Access Compliance Report

Public Rights-of-Way

(Curb Ramps)

Intersection ID: 15957	Main Street: MARYLAND_AV	Cross Street: STERLING_RD	Location: SW
ADA ID: 7617EF62A666	Ramp Type: PerpDiag	Initial Pass/Fail: Fail	Overall Compliance: No
Severity Score: 12.5			
Codes/Mitigation Info/Possible Solution		Field Measurements/Component Compliance

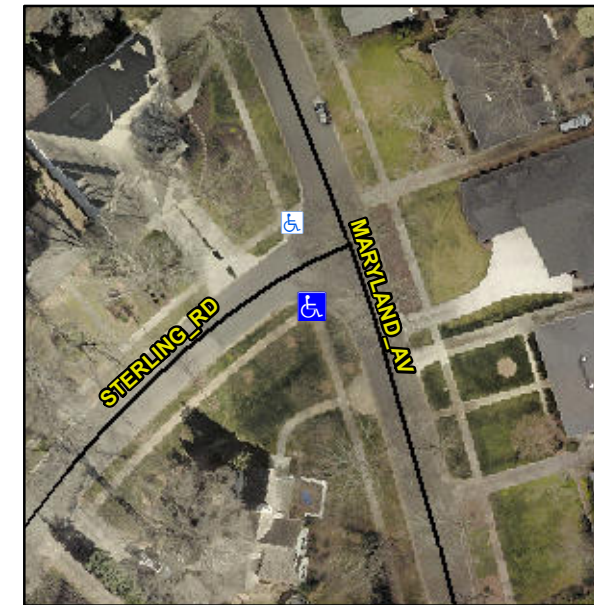
Not Found, R304.2.2

Compliance	Description	Data	Compliance	Description	Data
N/A	Ramp Length (in)	70.0	No	Ramp Slope (%)	8.5
Yes	Ramp Width (in)	48.0	Yes	Ramp XSlope (%)	0.7
N/A	Flare Type LT	N/A	N/A	Flare Type RT	N/A
N/A	Flare Slope LT (%)	N/A	N/A	Flare Slope RT (%)	N/A
N/A	Flare Traversable LT?	N/A	N/A	Flare Traversable RT?	N/A
N/A	Landing Length (in)	N/A	N/A	DWS Provided?	N/A
N/A	Landing Width (in)	N/A	N/A	DWS Contrast?	N/A
N/A	Landing Slope (%)	N/A	N/A	DWS Length (in)	N/A
N/A	Landing X Slope (%)	N/A	N/A	DWS Full Width?	N/A
N/A	Landing Curb? (Y/N)	N/A	N/A	DWS Offset (in)	N/A
N/A	Shared Landing?	N/A			
N/A	Gutter Ponding?	N/A	N/A	Gutter Slope (%)	N/A
N/A	Gutter Lip Ht (in)	N/A	N/A	Gutter X Slope (%)	N/A
N/A	Painted X Walk1?	No	N/A	Painted X Walk2?	No
	X Walk 1 Direction	To E		X Walk 2 Direction	To N
N/A	X Walk 1 Width (in)	N/A	N/A	X Walk 2 Width (in)	N/A
	X Walk 1 Slope (%)	3.0		X Walk 2 Slope (%)	1.3
	X Walk 1 X Slope (%)	2.8		X Walk 2 X Slope (%)	2.7

Remove & Replace Curb Ramp With Two New Directional Ramps or Equivalent.
